3070-91

S E R V I C E N O T E

Keysight i3070 Series 5 In-Circuit Test System

Control XTPA card new firmware 14091012_2.xsvf

Figure 1: Diagnostics error message

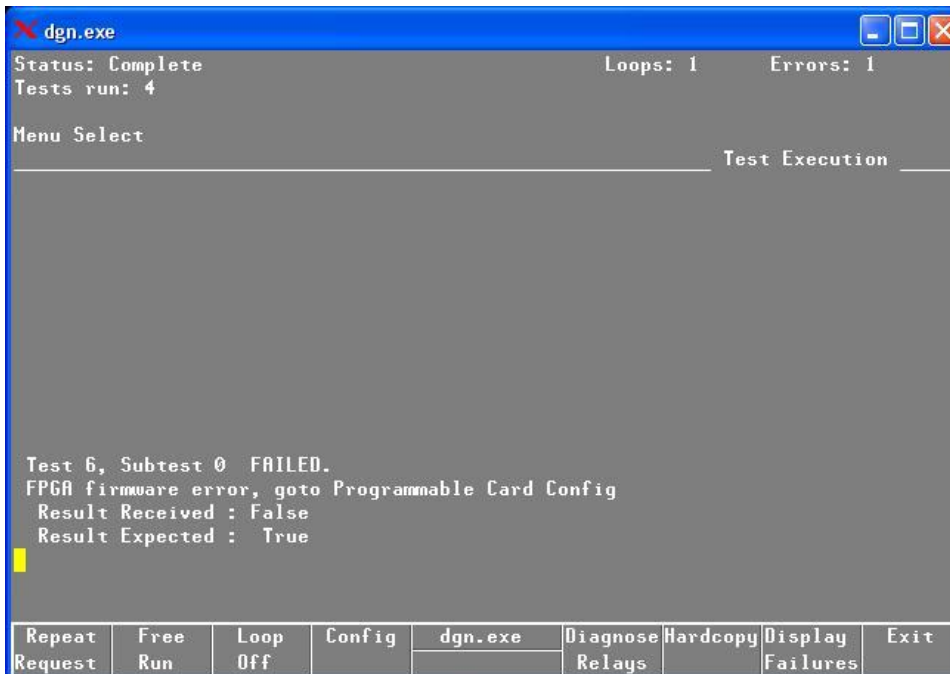
Users who have testheads that are installed with Control XTPA of one version and firmware release of another version may detected this differences at failing diagnostics “Test 6, Subtest 0” with the error “FPGA firmware error” (Figure 1). This is a symptom that the firmware versions are different.

- A. Check the firmware version on Control XTPA card
 - 1) Execute the testhead diagnostics application by double clicking on the “DGN” icon on the desktop (alternatively, type “dgn” at the command prompt in a shell window)
 - 2) To boot up the testhead,
 - i. Click on “Testhead Functns” (F4) and click on “Testhead Power On” (F1)
 - ii. After the testhead is booted up, click “Exit” till Service Package - Level 1.
 - iii. Then, select “Configuration”, follow by “Programmable Card Configuration”.
 - iv. Check on Actual and Expected value and execute the recommended action listed below.

Figure 2: Location of P4402 jumper

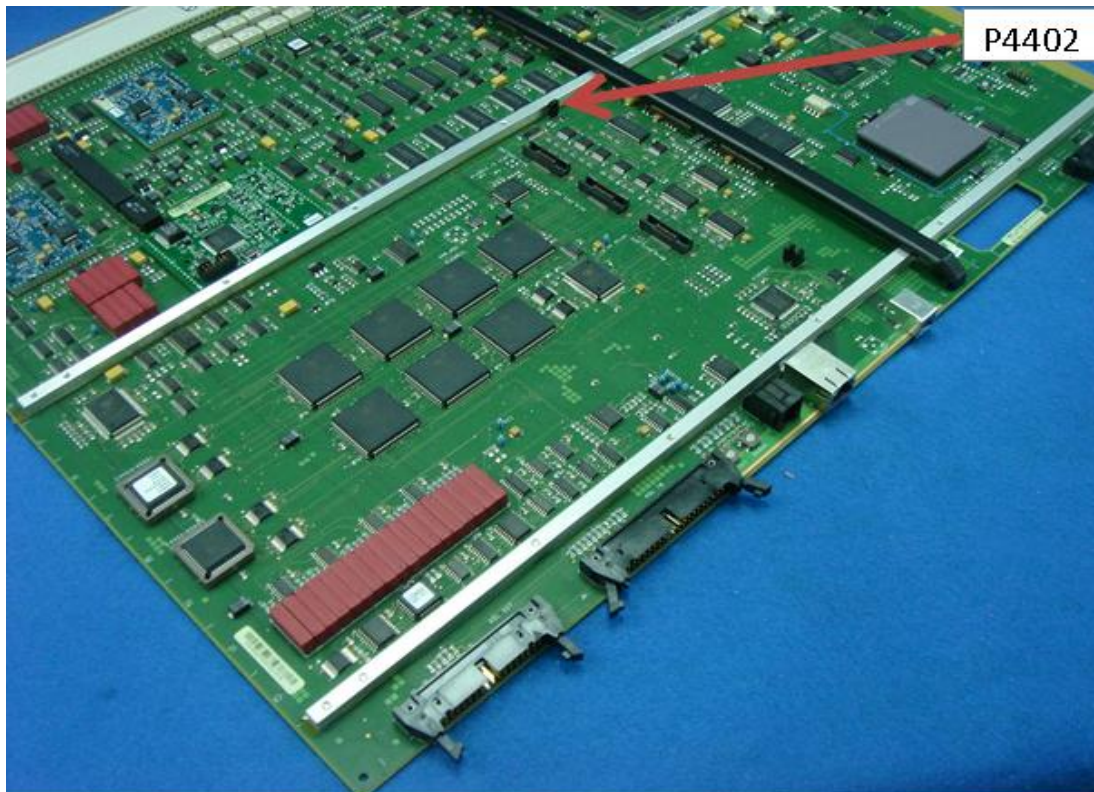
- 4) Click on “Update All” (F1) button to program all the Control XTPA cards.
 - 5) Please ensure that the jumper P4402 is in an open position to allow In-System Programming. It is recommended that it is put in closed position (write protect) during normal operation.

Figure 3: Diagnostics firmware version

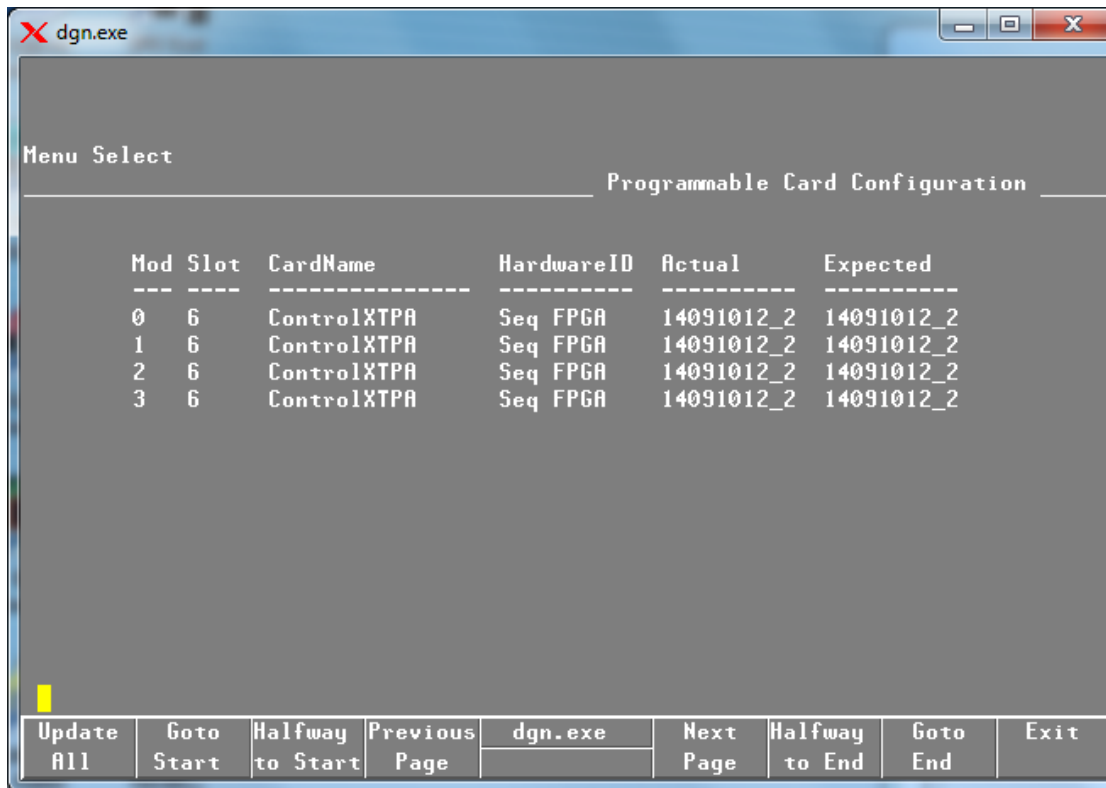
- 1) Reboot the testhead and check the firmware version on Control XTPA card. (Note: Please refer to step "A" for checking procedure)
- 2) You should notice the Actual and Expected value show as "14091012_2" (Figure 3).
- 3) Click "Exit" till "Service Package - Level 1" Page. Then, select "Autoadjust All", follow by "AutoAdj All" (F6).
- 4) Proceed to production once Autoadjust Passed.
